Alaska Department of Environmental Conservation

Amendments to: State Air Quality Control Plan

Volume III: Appendix III.K.6 Best Available Retrofit Technology (BART) Documentation

APPENDIX III.K.6
BART Documentation

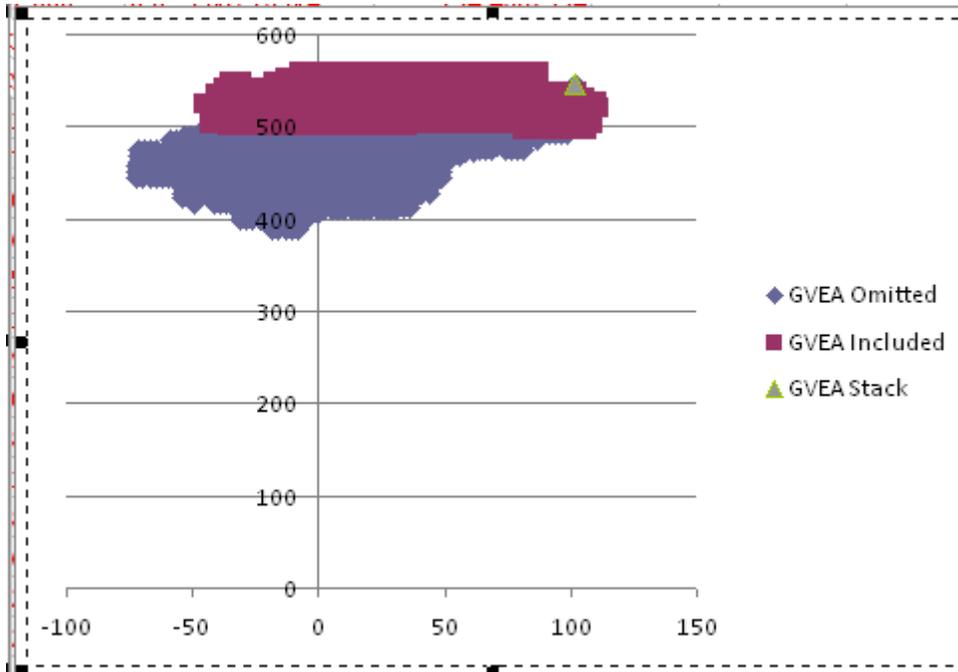
It is noted that the Auxiliary #1 Boiler revised maximum visibility impact presented above occurred at a location included in GVEA’s visibility modeling analysis. Therefore, the revised

maximum impact is attributable solely to the corrected unit NO_x and SO₂ emission rates. The 776 previously omitted receptors are relatively distant from the Healy Power Station, and the 591 receptors initially modeled by GVEA are located in relatively close proximity to the plant and remain the dominant receptors in this analysis. The figure below shows the locations of these groups of receptors relative to the Healy Power Station.
